SUBJECT: Vac Ion

ATTACH. #2-B

SUBJECT: Vac Ion Power

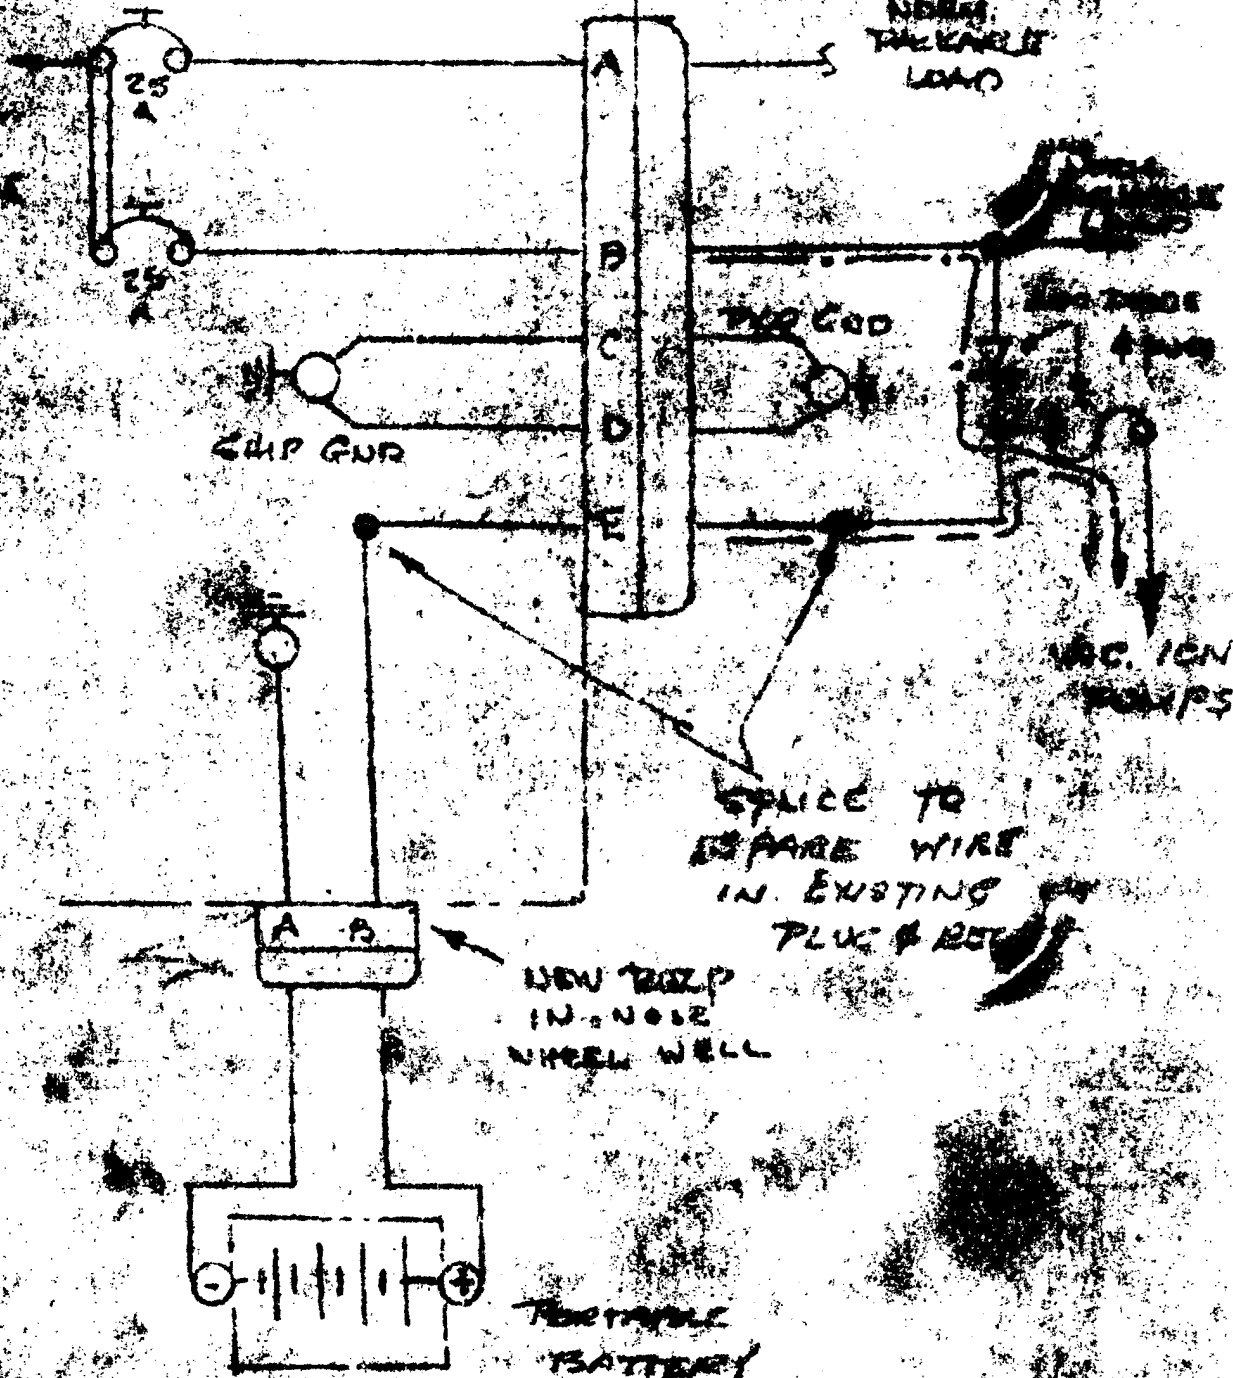
a. We would like to eliminate the fuse between the diode and the vac ion power supply as is suggested since it would increase our reliability. Unless there is some objection from the vehicle people, which we don't foresee, we will omit this fuse.

b. We would like to know the type of connector they are planning to use in the wheel well so that we can make up our battery and harness to mate.

c. [REDACTED] will assume the responsibility of making the necessary changes in our harness (on the package side of Q5) to accommodate the diode and "E" wire. He will make up a suitable jumper harness so that the vac ion supplies will run without the system package.

} afraid of back flow thru relays, ok
Keep Diode, eliminate fuse
